Subject Coal & Allied Southern Estates – Nords Wharf (MP10-0088)

**SSS Listing & Concept Plan – Up to 90 Dwellings, The Dedication Of Approx
117 Hectares Of Conservation Land and Associated Infrastructure**

Schedule Of Issues

Proposed Concept Plan - Upto 90 Dwellings, The Dedication Of Approx 117 Hectares Of Conservation Land And Associated Infrastructure – Lake Macquarie City Council Submission

Photo 2: Existing public access along the foreshore in front of the development area

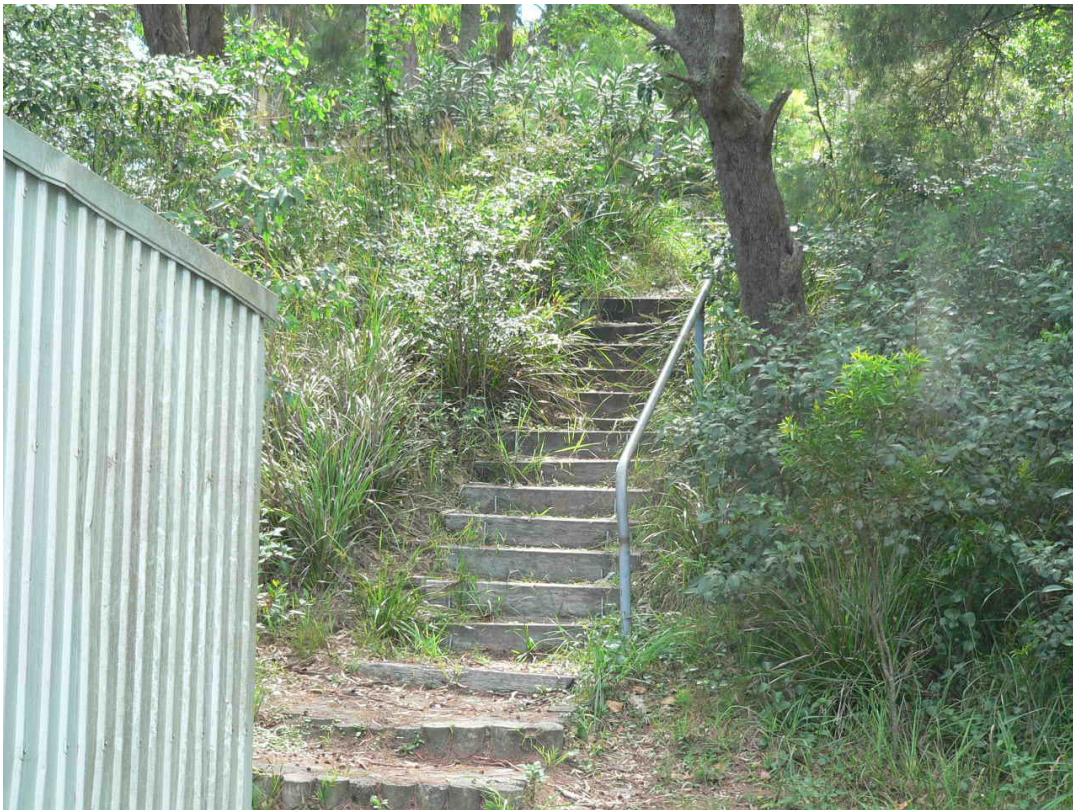
Photos 2, 3 and 4 indicate the land is currently a foreshore parkland area. The DGEARs are to provide new opportunities for public access. New opportunities may include the provision of seating at appropriate locations.
